APPLICATION NO:
F/2001/5254

LOCATION:
27 Haddon Drive, Woodley Reading.

PROPOSAL:
Proposed two storey side extension to dwelling and single storey rear extension.

Appeal Decision

ADDITIONAL PLAN
5254
34
30
22
14
HADDON DRIVE
HADDO
3
2
4
5
1
21
REFUSED
29
33
PROPOSED EXTENSION.
1:500 BLOCK PLAN
27 HADDON DRIVE.
Revised 22/11/01
2 5 NOV 2001
COPIES TO:

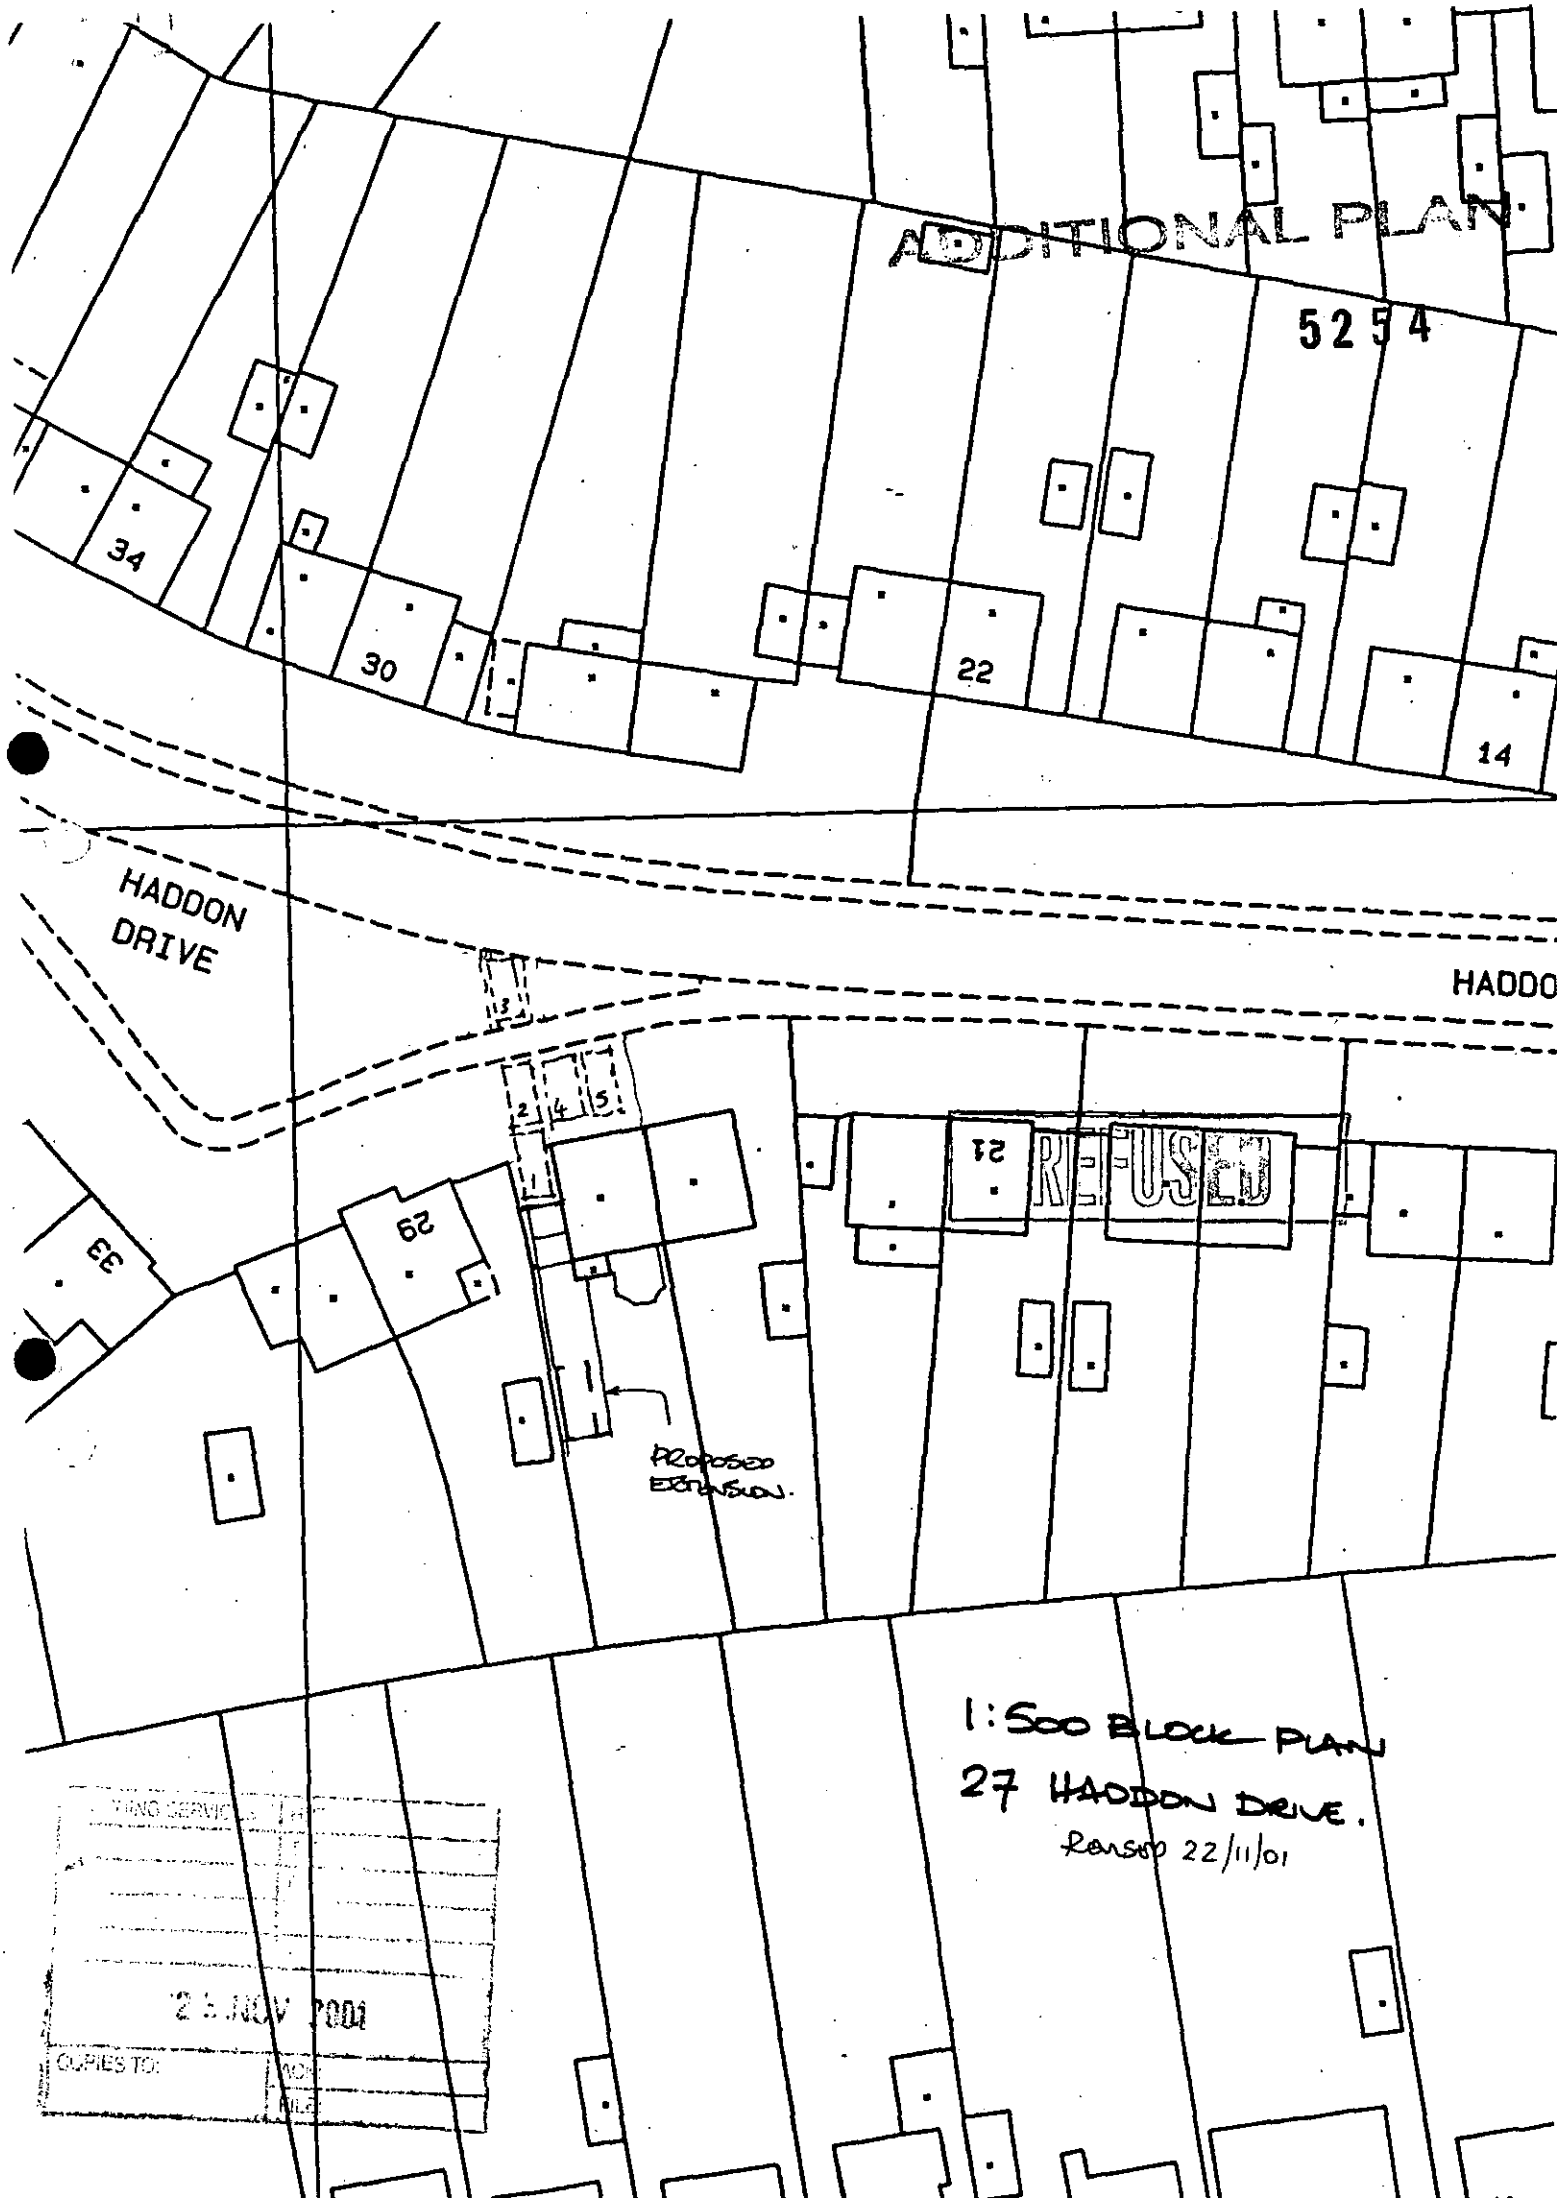
The space no. 3, as identified on the revised plan, is unacceptable as it is not within the curtilage of the property.

27 Haddon Drive Woodley
Plan1 1:100

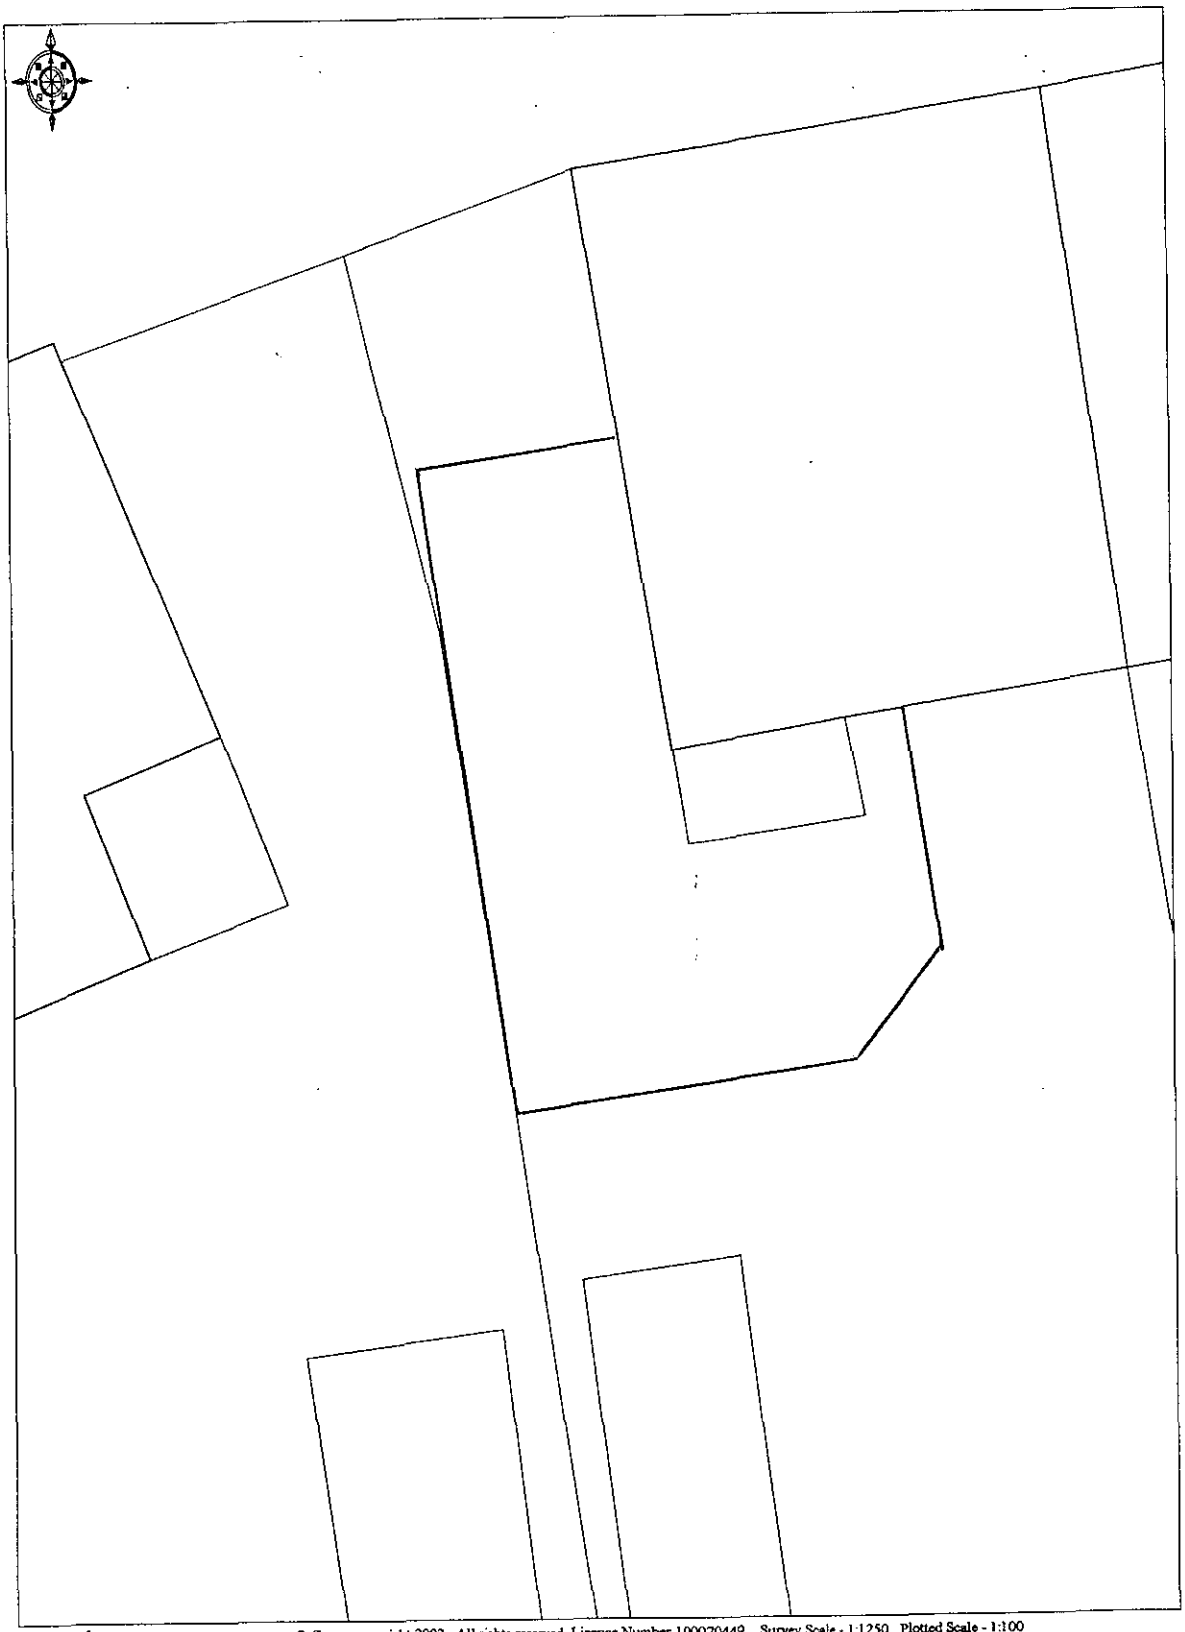
however, is uncertain. The quality of drawing 0124/03A is poor. I have overlaid the Appellant's drawing on an Ordnance Survey sheet, also plotted to a scale of 1:100. This is my Plan 1 in Appendix 3. The extension oversails the boundary with no. 29 for a boundary length of about 5 metres. This is on the basis that the scale width of the side extension is 2.6 metres from the existing external face of no. 27. However, the Appellant's expert's comment at paragraph 5.05 suggests that this width is 2.8 metres. This would result in the building being constructed on my clients' freehold property to a width of 0.2 metres.
